Florida Power & Light/St. Lucie's First Six-Month Status Report to the Overall Integrated Plan in Response to March 12, 2012 Commission Order to Modify Licenses with Regard to Reliable Spent Fuel Pool Instrumentation (Order Number EA-12-051)

**FLORIDA POWER & LIGHT
ST. LUCIE NUCLEAR POWER PLANT**

**FIRST SIX MONTH STATUS REPORT FOR THE
IMPLEMENTATION OF ORDER EA-12-051, ORDER MODIFYING
LICENSES WITH REGARD TO RELIABLE SPENT FUEL POOL INSTRUMENTATION**

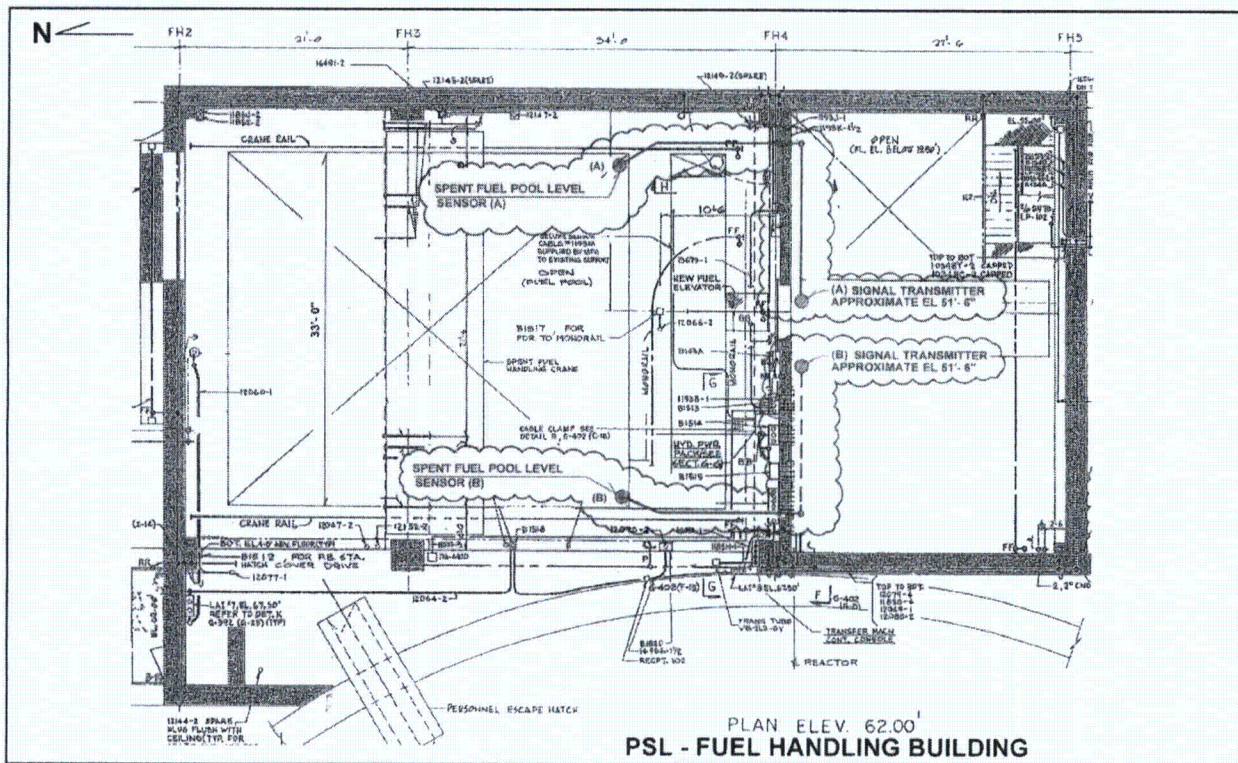
RAI-2

Please provide a clearly labeled sketch or marked-up plant drawing of the plan view of the SFP area, depicting the SFP inside dimensions, the planned locations/placement of the primary and back-up SFP level sensors, and the proposed routing of the cables that will extend from the sensors toward the location of the local electronics cabinets and read-out/display devices in the main control room or alternate accessible location.

the primary and backup SFP level sensors will be installed in the South side of each unit's SFP, as close to the opposite corners as practical to maintain maximum attainable separation. Sensor conditioning electronics and battery backup will be mounted in a remote location separated from the SFP by a reinforced concrete wall(s) which will provide suitable radiation shielding for the electronics.
